ADDITIONAL INFO
REVISION

Re: VWP Individual Permit Number 14-0343 - Minor Modification Request for Intake Relocation and Raw Water Transmission Line Extension
James River Water Supply Project, James River Water Authority

JRWA RAW WATER INTAKE, PUMP STATION AND FORCE MAIN

JAMES RIVER WATER PROJECT
JAMES RIVER WATER AUTHORITY
RAW WATER INTAKE AND PUMP STATION

ENVIRONMENTAL IMPACT SUMMARY

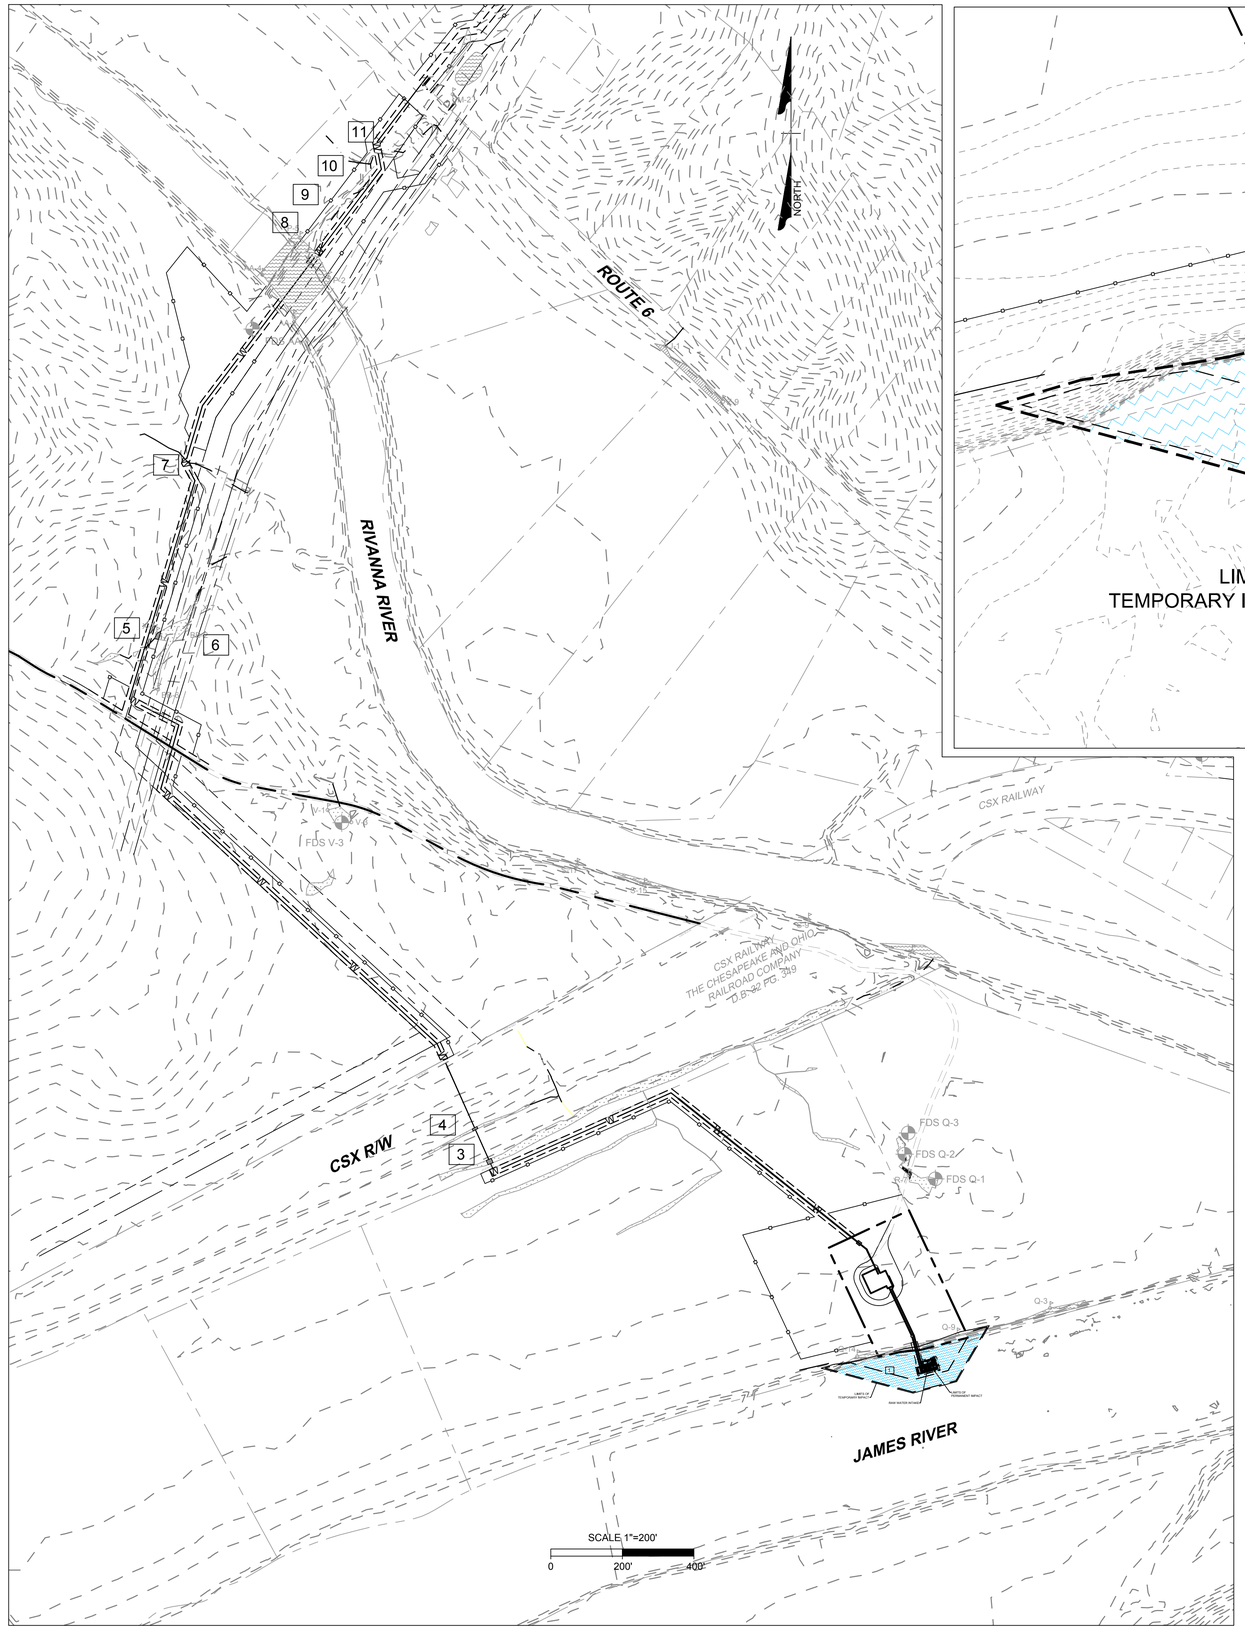
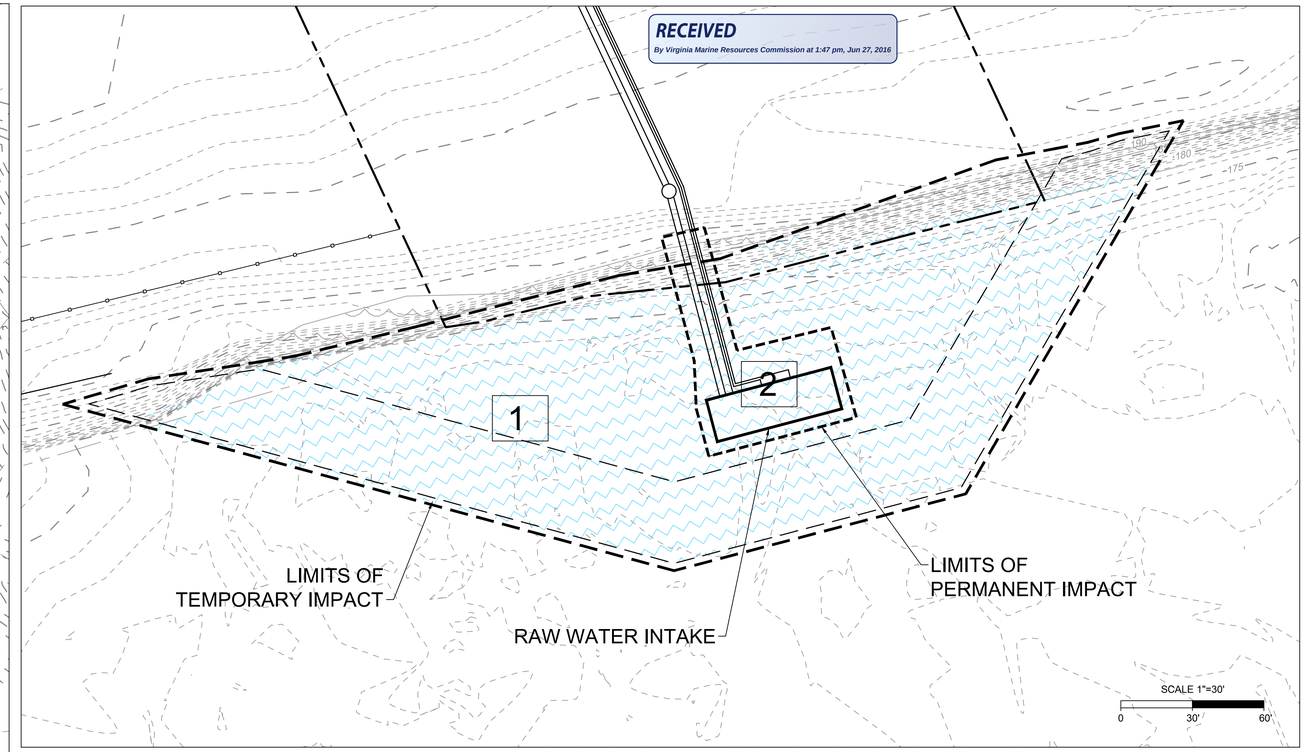
1. Intake Structure: Impacts to the James River associated with the construction of the intake structure are **0.90 acres (or 39,000 SF) and 485 linear feet of temporary impact (same as before)** and **0.080 acres (or 3,470 SF) and 64 linear feet of permanent impact.** Previous authorization allowed for impacts of 0.90 acres (485 linear feet) of temporary impact and 0.09 acres (64 linear feet) of permanent impact for the construction of the intake structure.

NOTE: INTAKE STRUCTURE RELOCATED APPROX. 250 UPSTREAM

RAW WATER MAIN RIVANNA RIVER CROSSING

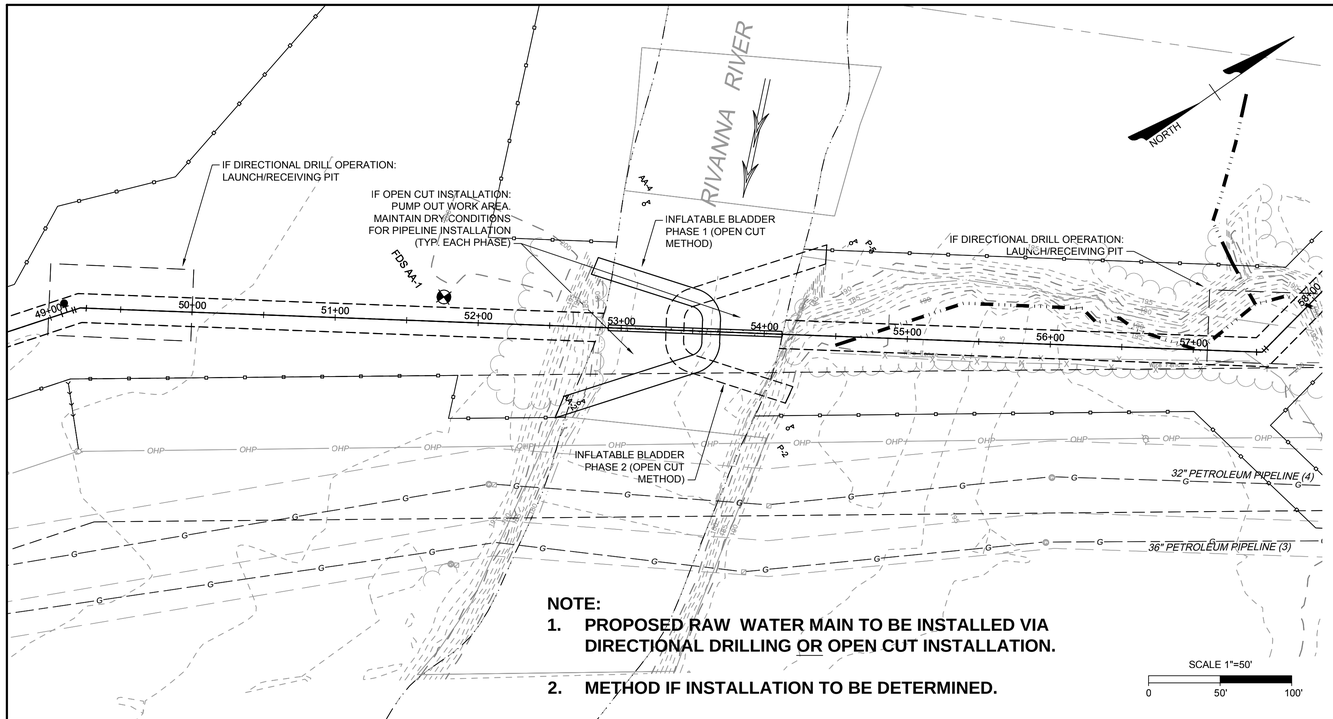
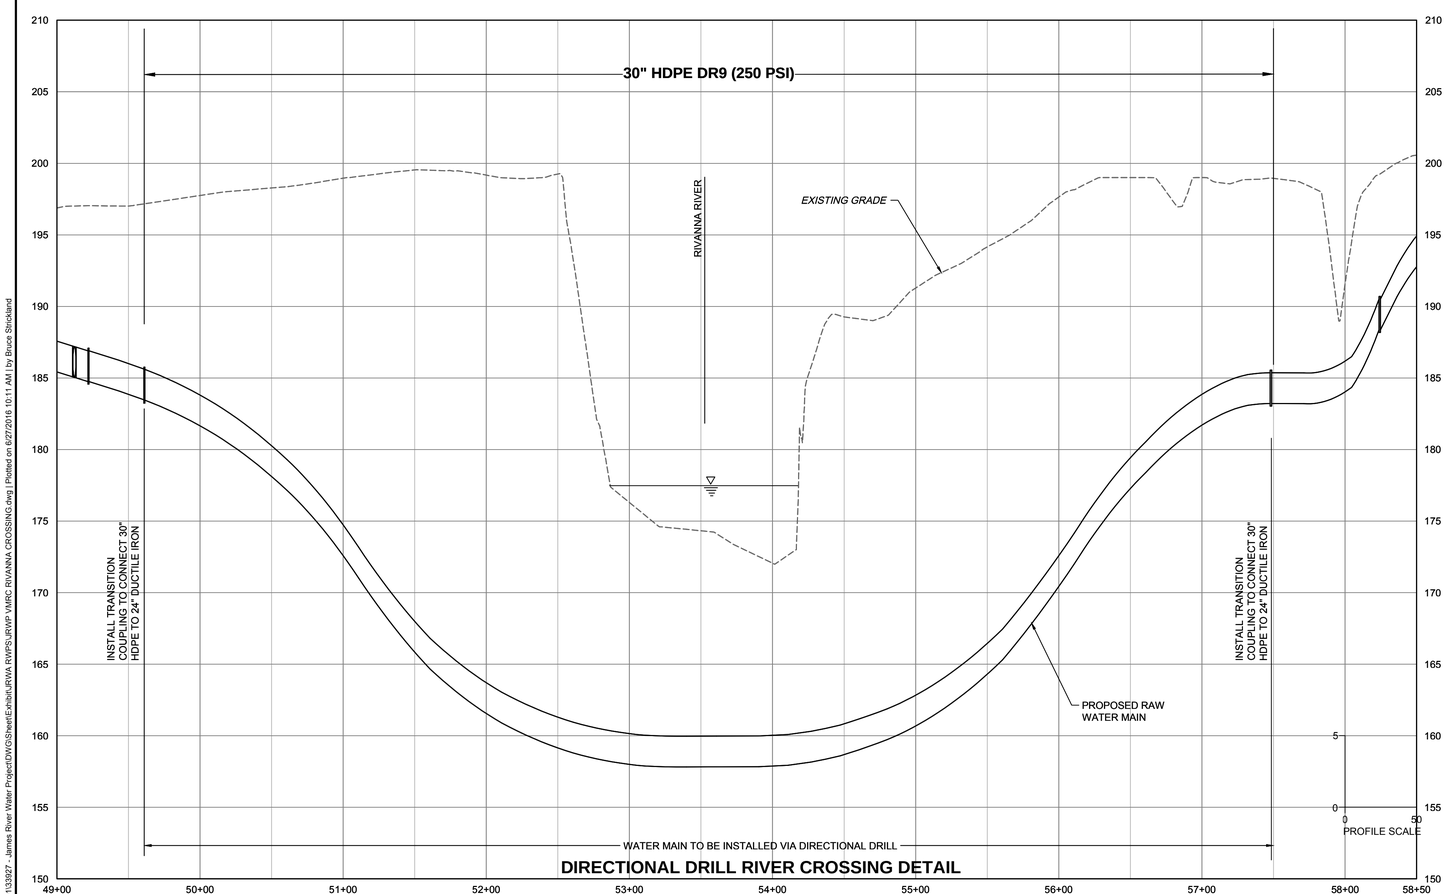
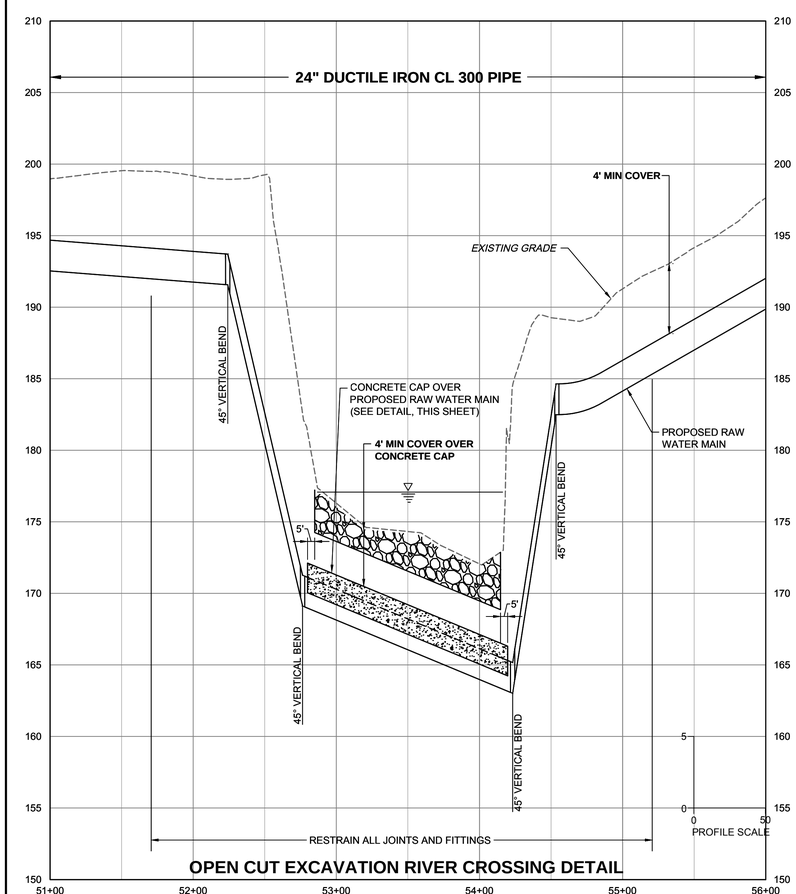
On behalf of the James River Water Authority (JRWA), we are requesting a minor modification to the above referenced permit, in accordance with VWP Regulation 9VAC25-210-180, for the relocation of the intake structure to approximately 250 linear feet upstream of the currently authorized location. We are also requesting VDEQ to allow the JRWA the option of open cut or directional drill the raw water line crossing at the Rivanna River.

1. **PROPOSED RAW WATER MAIN TO BE INSTALLED VIA DIRECTIONAL DRILLING OR OPEN CUT INSTALLATION.**
2. **METHOD IF INSTALLATION TO BE DETERMINED.**
